Zion Nuclear Power Station, Units 1 and 2

**Response to Request for Additional Information Related to the
Final Status Survey Final Reports**

Zion Nuclear Power Station, Units 1 and 2 – Request for Additional Information Related to Final Status Survey Reports, dated November 4, 2020

Addendum 1
FSS Maps
Page 6 of 6
Scan Grids

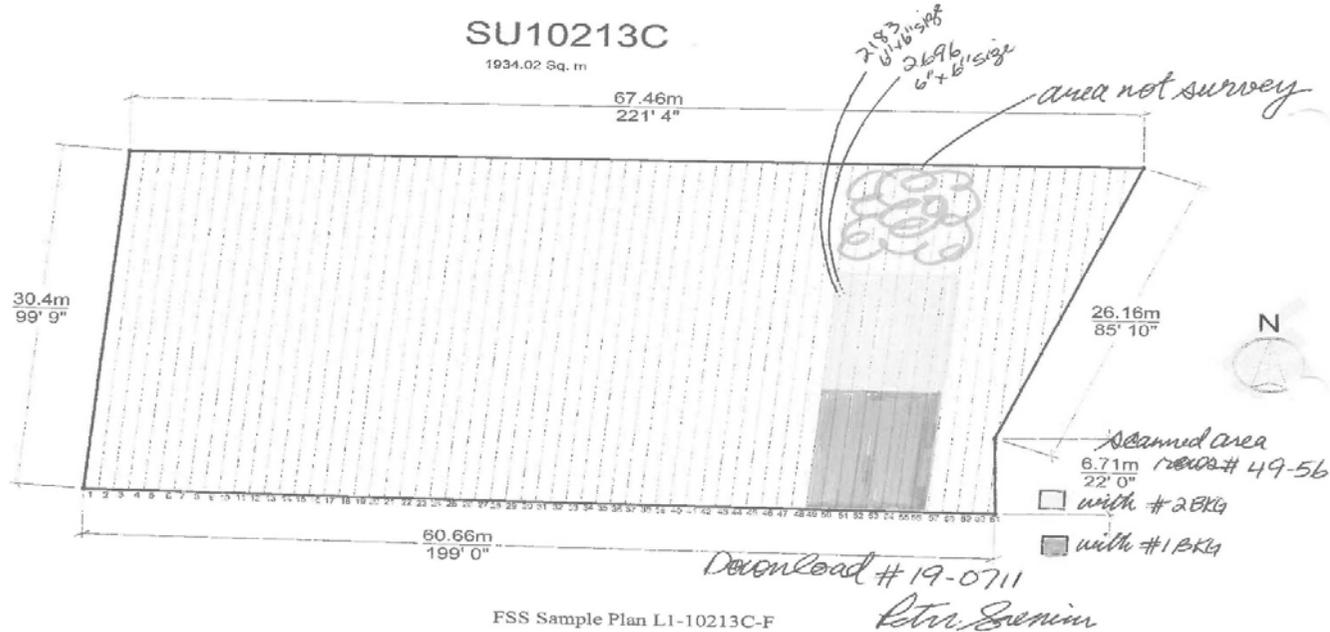
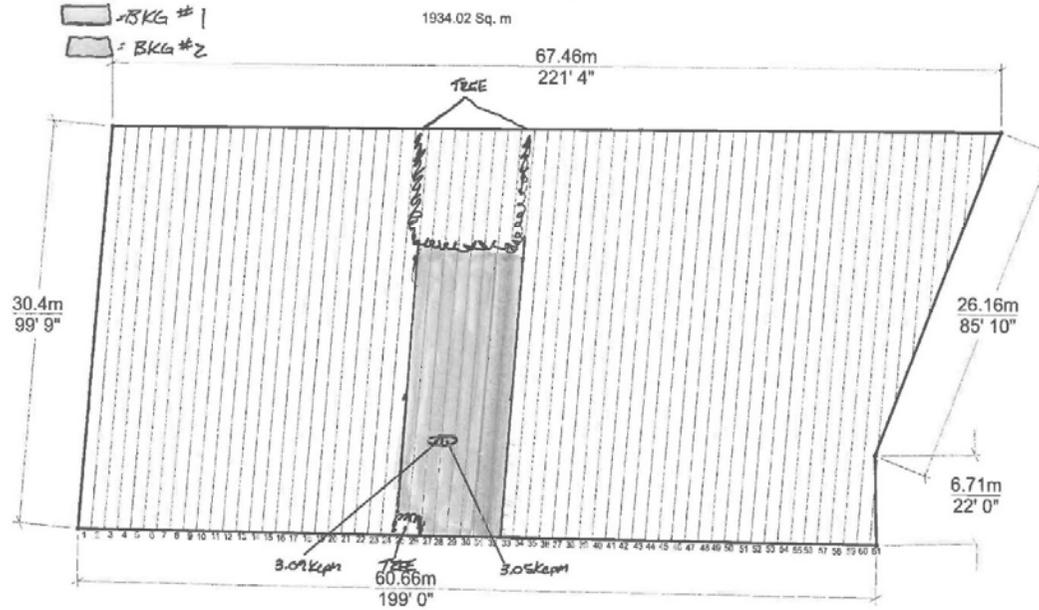
NRC RAI Question #3d For the portion of 10213C that was scanned with ice greater than 2 inches of snow/ice being present, adjust the scan data to account for attenuation through the snow.

NRC Supplemental RAI Question #3d (January 21, 2020) Licensee should provide supporting technical analysis showing the results are still appropriate given that there was 1 inch of snow. Licensee did not appear to adjust the scan data to account for a 1-inch snow cover between the detector and land, the scan speed for snow, different surface efficiency, etc. The scan MDC will also change with a 1-inch snow cover so the technical basis for the MDC should address that. Provide relevant procedures for conducting scans with 1-inch snow cover.

RESPONSE: The release record for survey unit 10213C states the following, “On November 13, 2019, the accessible areas of rows 25-40 and the middle section of rows 9-16 were scanned with greater than 2 inches of snow/ice being present. These conditions did not ensure that the detector end-cap was within 2 inches from the ground surface as specified in the FSS Plan. These areas were scanned again on November 16, 2019, when there was only up to 1 inch of snow present. The alarms that occurred in rows 27 and 28 on the earlier scans (see Section 9 for further discussion) could not be reproduced on the subsequent scans, and no elevated areas were identified during these scans.” Therefore, as the initial scans were not performed in accordance with procedure, they were not considered as valid FSS data and were omitted from the data set and replaced with the scan data from November 2019. The inclusion of this paragraph into the Anomalies section of the release record was provided as an explanation of why the scans were performed again.

RESPONSE: The scan MDC was established in TSD 11-004, which follows the guidance in MARSSIM and NUREG-1507. The hotspot model for Zion was a 0.196 m² (50 cm diameter) area by 15.24 cm deep soil area. To account for the potential impact of snow on the ground, some additional MicroShield runs were performed using the same hotspot model including snow. Snow is frozen water and Snow Water Equivalent (SWE) is a common snowpack measurement. It is the amount of water contained within the snowpack. It can be thought of as the depth of water that would theoretically result if you melted the entire snowpack instantaneously.

An additional review of the survey unit 10213C release record scan surveys for the snow affected areas was performed. Scan surveys were conducted in a portion of the survey unit with up to 1 inch of snow cover on the ground surface. Since the scan surveys could be performed while maintaining the detector end-cap within 2 inches of the ground surface, there were no changes or modifications to the procedures. No elevated areas or additional areas for investigation were identified.

Survey Unit 10221D

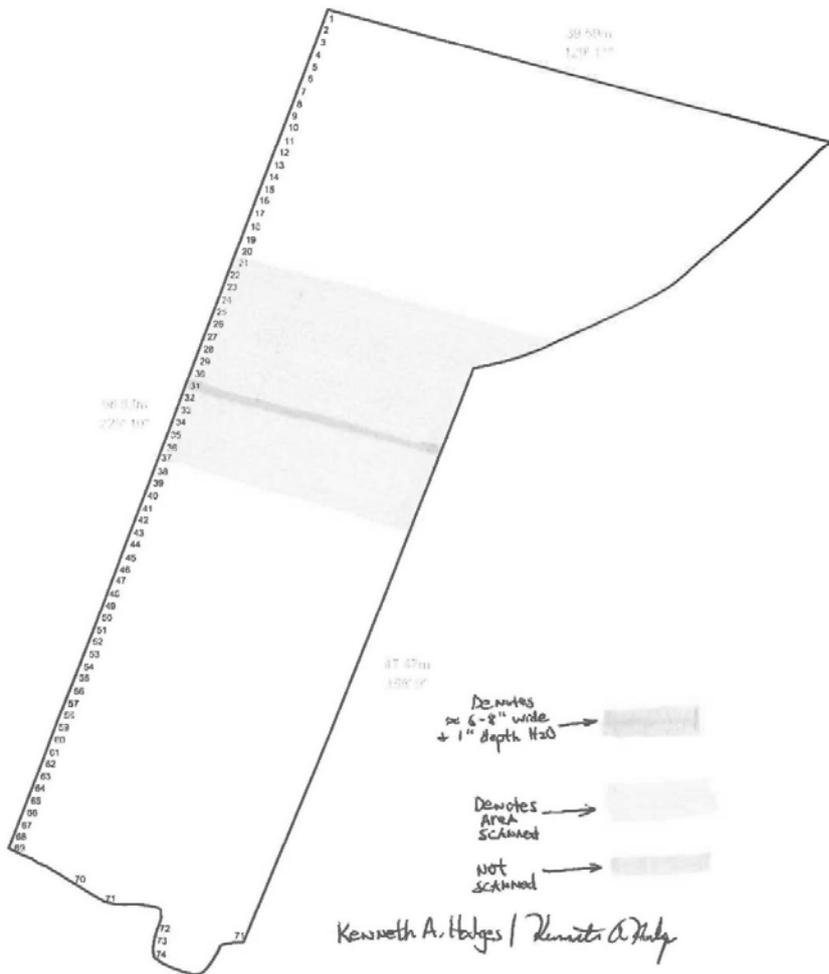
NRC RAI Question #3c Provide a justification that there is reasonable assurance that the survey units described above meet the 25 mrem/yr unrestricted release criteria despite the fact that some areas within the survey unit were not scanned. This justification should include an evaluation of the results of other samples or scans in and around the areas that were not scanned. Include whether contamination is known to exist or a high potential for contamination exists in these areas.

- Survey Unit 10221D – The surface in question was a 1.6 m² area obstructed by standing water. The area is described as the approximate center of the survey unit between scan rows 22 and 30. The area of the survey unit that was subjected to scans equates to 99.81% areal coverage of the open land surface in this survey unit, which was completely scanned with no alarms. Additionally, systematic soil samples L1-10221D-FSGS-009-SS and L1-10221D-FSGS-010-SS were taken on both sides of the obstructed surface. A concentration of 9.25 E-02 pCi/g for Cs-137 was positively detected in sample L1-10221D-FSGS-010-SS. The concentrations for all other ROC were less than MDC. Based on the scans and soil sample results, it can be concluded that the potential presence of residual radioactivity at concentrations exceeding background in the obstructed areas was negligible. As such, no additional investigations were required. It can be reasonably concluded that the summation of the mean dose fraction for each ROC from the systematic sample population is

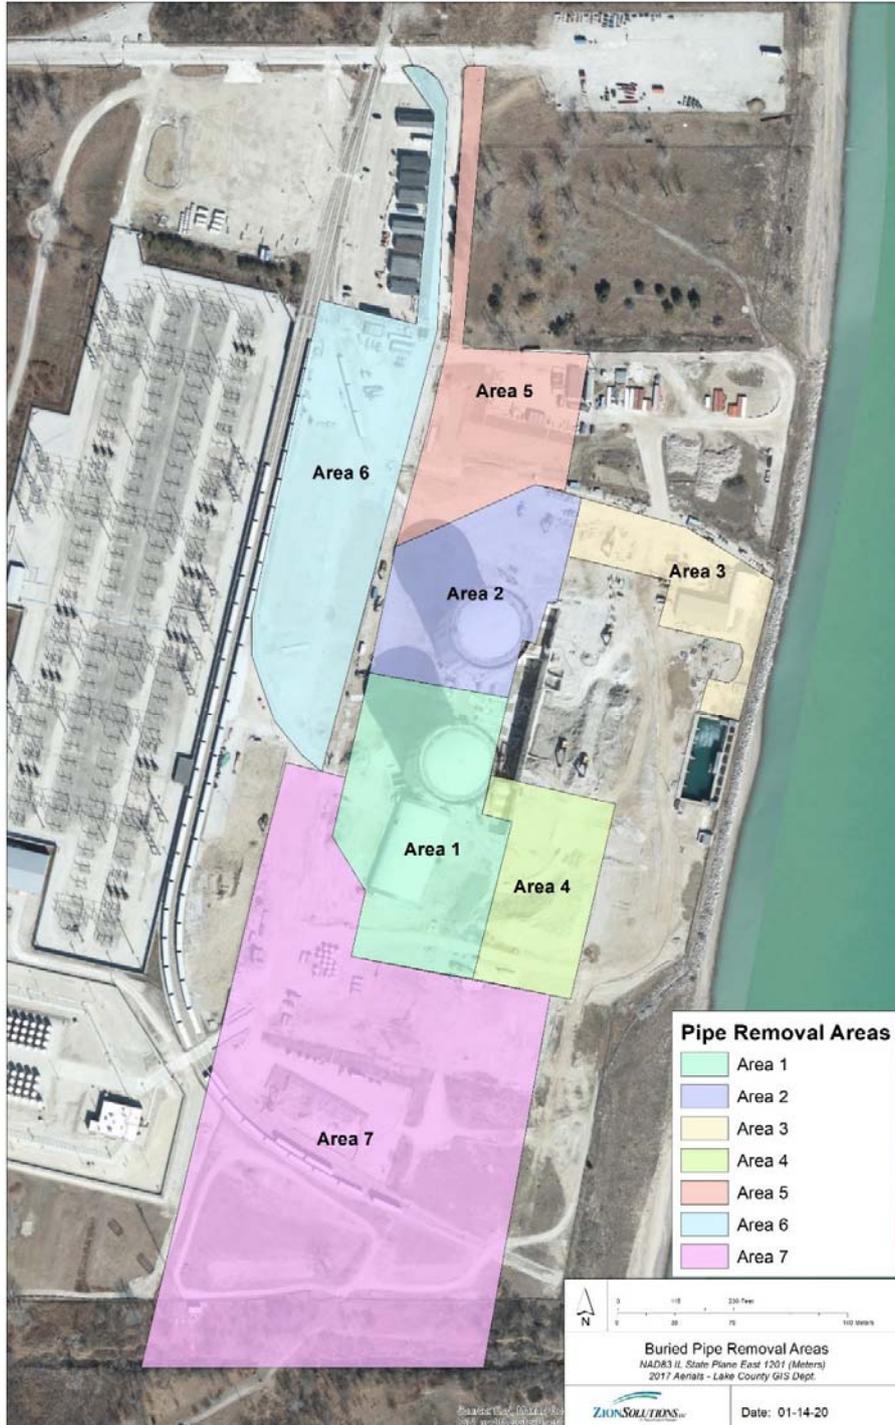
NRC RAI Question #8a Provide additional information on any land survey unit where buried piping or subgrade piping systems were removed that required subsurface remediation before FSS (e.g., WWTP subsurface piping), including the results of the post-remediation surveys.

A graphic depicting the approximate locations of the buried pipe that was removed, broken into seven areas, is provided below. On the enclosure to this response, ZionSolutions has provided the spreadsheet documenting the soil sample analysis results for all soil samples acquired to assess the acceptability of excavation overburden prior to backfill into the excavation from which it was obtained.

Sample Map for FSS of Survey Unit 12112 from January 2019

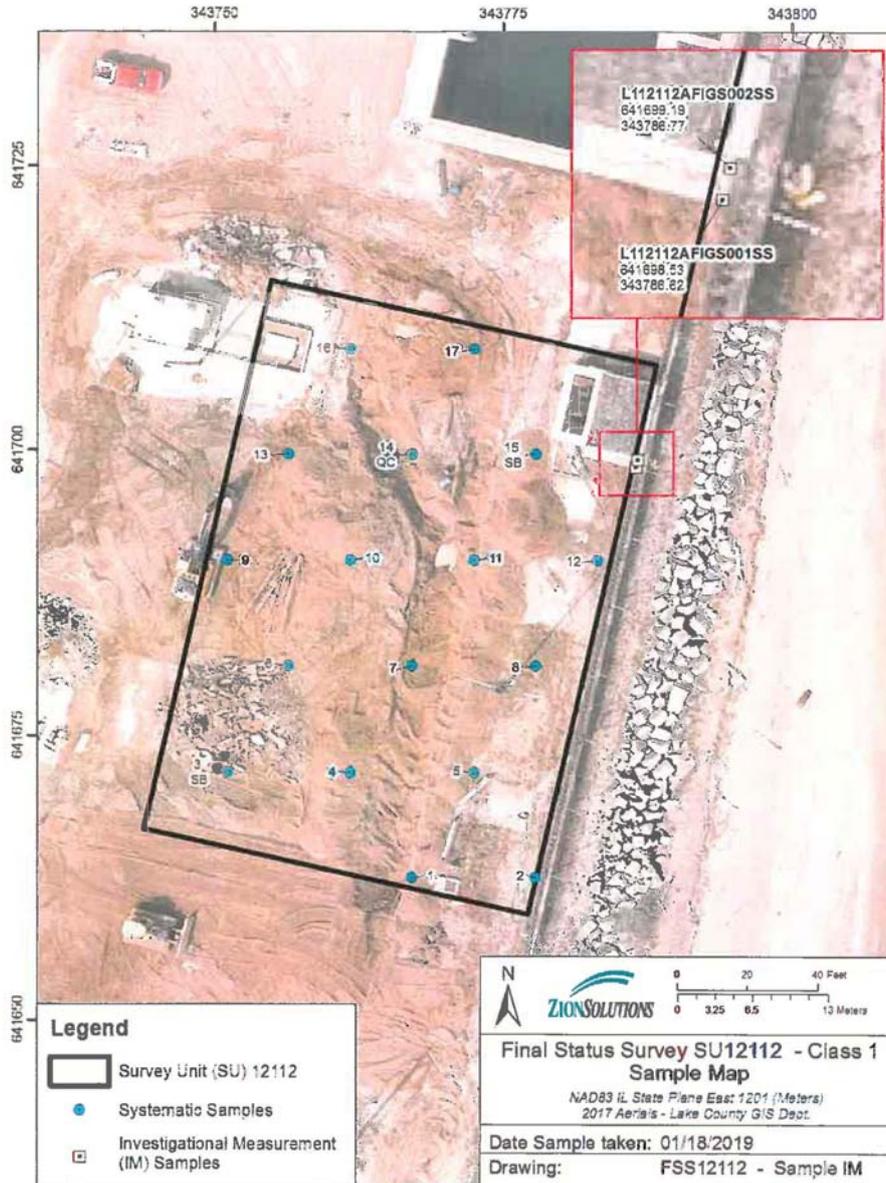
NRC RAI Question #11c For Survey Unit 12112, provide information on the location of sample L1-12112A-FQGS-014-SS in relation to the location of the scan alarms in rows 41 and 42. Also provide information on the location of both sample L1-12112A-FQGS-014-SS and the scan alarms in rows 41 and 42 in relation to the scan alarms. If the scan alarms did not identify the particle observed in sample L1-12112A-FQGS-014-SS and/or the elevated area observed by ORISE, provide information on the reason that the scan might have missed the particles.

RESPONSE: Below is a picture identifying the location of L1-12112A-FQGS-014-SS in relation to the scan alarms in rows 41 and 42 of Survey Unit 12112. The scan alarms occurred at location of soil samples L1-12112A-FIGS-001-SS in row 41 and L1-12112A-FIGS-002-SS in row 42. The location of L1-12112A-FQGS-014-SS is annotated in map by marker 14-QC.

The scan alarms in rows 41 and 42 identified by ZS were in similar location in which ORISE identified elevated measurements. The cause of the elevated measurements in these locations were due to NORM and not DRPs as discussed in further detail in the RAI #10a response. A DRP of source strength similar in nature as to that identified in soil sample L1-12112A-FQGS-014-SS would not have been identified during scans as it would be below the MDA of the detector as discussed in further detail in the RAI #11a response.
